Re: Proposed Preliminary Site Plan For 5216 Seminary Road

ARGUMENTS AGAINST PROPOSED PRELIMINARY SPECIAL USE PLAN

Opposition To Plan For 7 Large Townhouses For 5216 Seminary Road

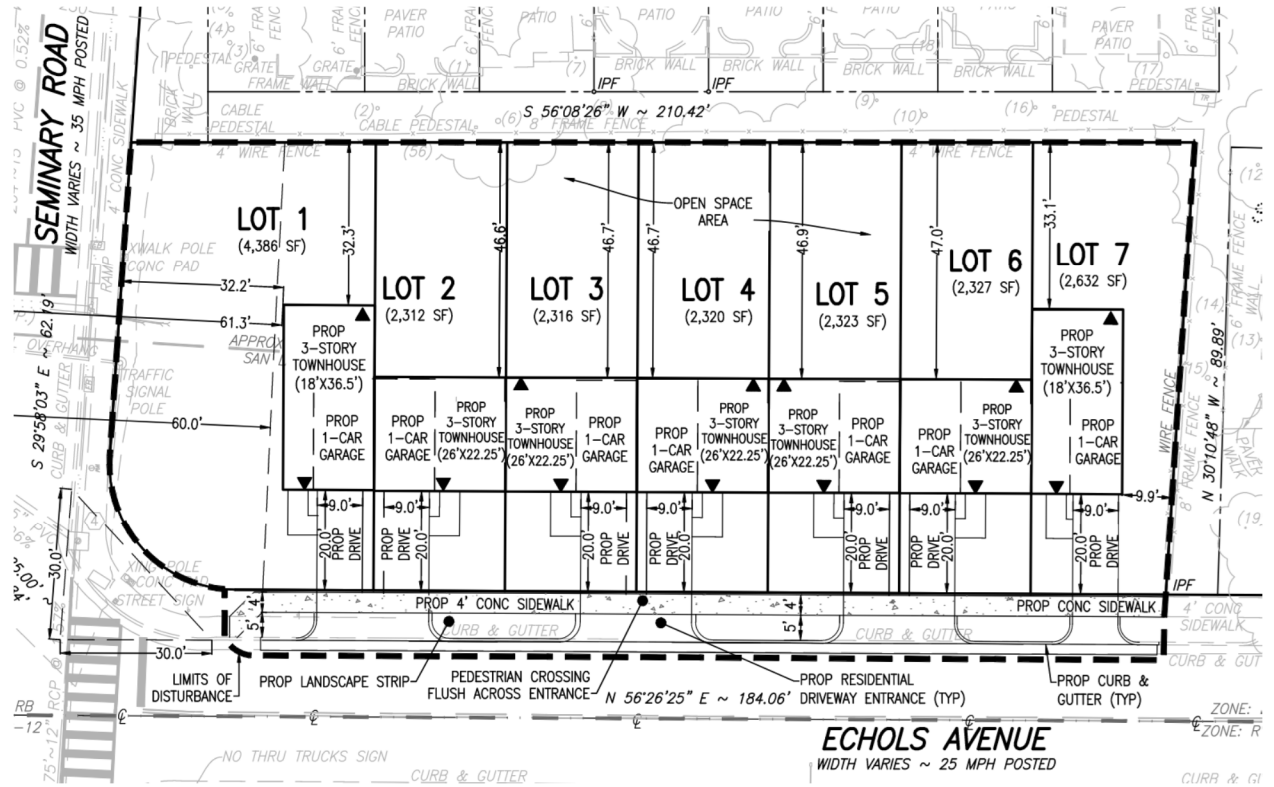
It is apparent that the floor area under the cluster design is much larger both on a lot-by-lot basis and in total.

We note we are skeptical that the applicant's diagram that the non-cluster design with the 29-foot high buildings are credibly 3-stories. If not the square feet calculations would be even smaller for the baseline proposal.

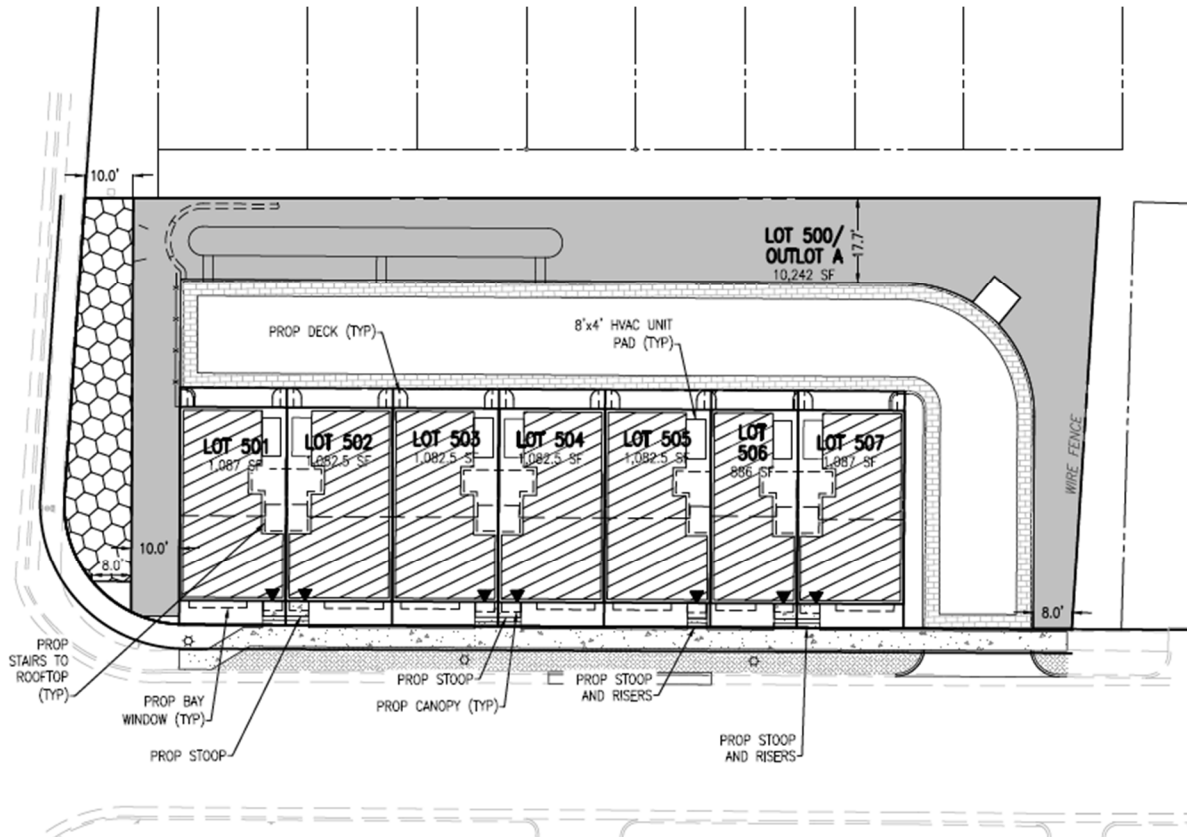
6. The rooftop areas do not meet the terms under 11-604 (A) for “an equivalent amount of suitable land”. The rooftops are not land. The rooftops are not common space as they have divisions between. The roof tops are really decks. The rooftops are not open and usable space.

7. Under Section 2-180 open and usable space is that portion of a lot at ground level which is in part is no less than eight feet in width and length and not used in whole or in part as driveways. The purpose of open and usable space is to provide areas of trees, shrubs, lawns pathways and other natural man-made amenities which function for the use and enjoyment of residents, visitors and other persons.

8. The trade from what was previously open space in the baseline diagram to the new, larger building footprints is also a trade that goes in the wrong direction.

ECHOLS AVENUE

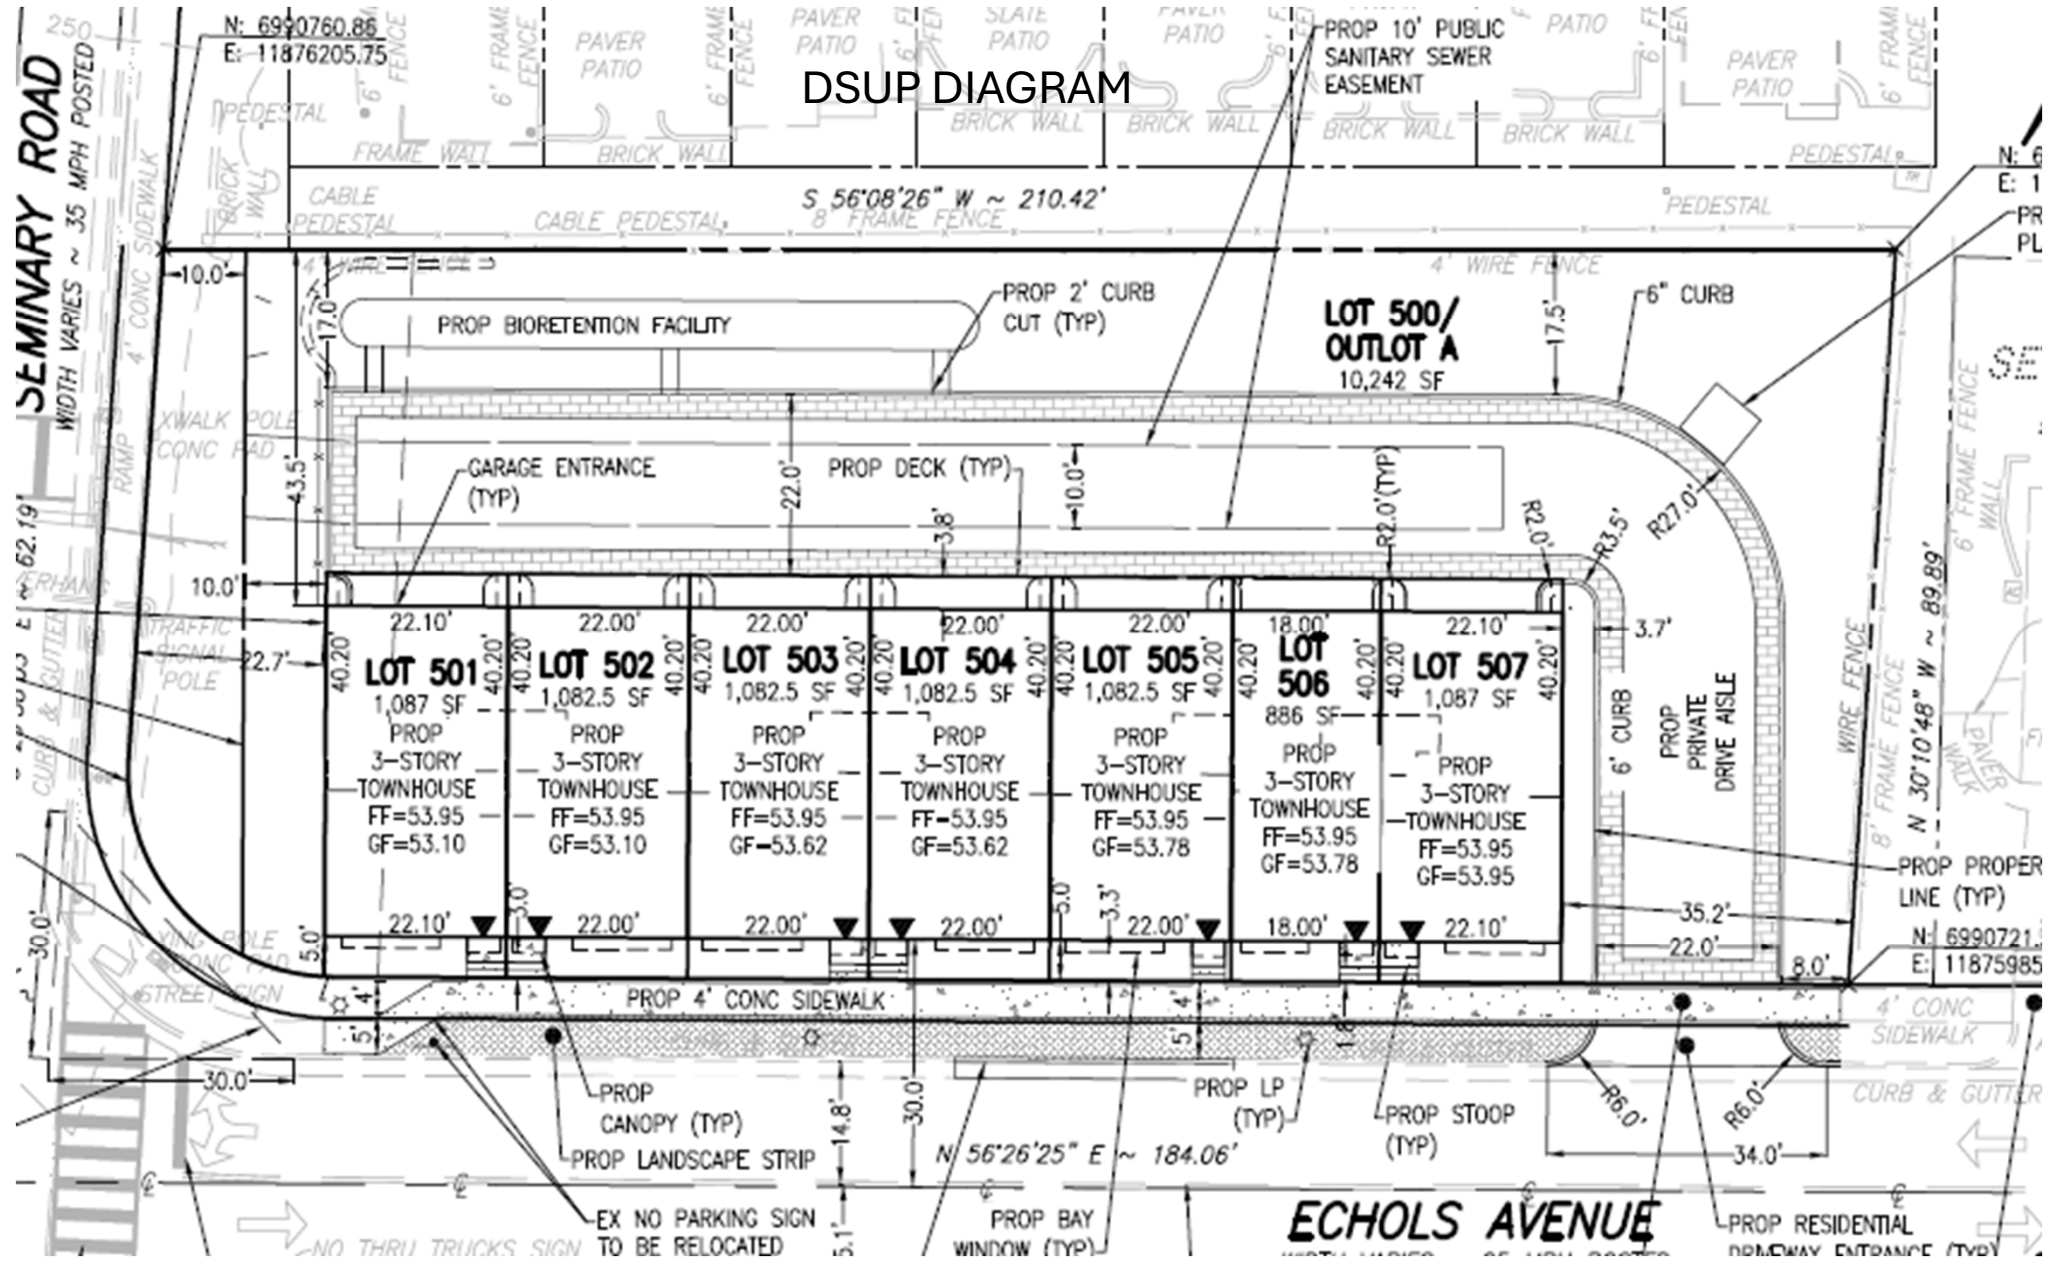
The Applicant Fails By Using Smaller Townhouses In the Baseline Than They Intend For the DSUP (1)

- 11-605-(B)(1) requires a general layout plan depicting the density, design and development potential of the subject property under all regulations of the applicable zone without a cluster design
- The 7 larger townhouses would fail the ordinary requirements
 - The larger townhouses fail because a 20 ft front yard requirement + 40 ft townhouse + 44 ft rear yard requirement (1:1)=104 ft
 - The depth of the lot is only 90 ft
- The baseline townhouses are a lot smaller
 - As an example, the baseline townhouses are 29 feet high instead of 44 feet for the DSUP townhouses
 - The ground dimension is 26 ft x 22.25 ft for the 5 middle townhouses instead of what appears to be 22 ft x 40.2 feet for 4 of the middle in the DSUP Townhouses
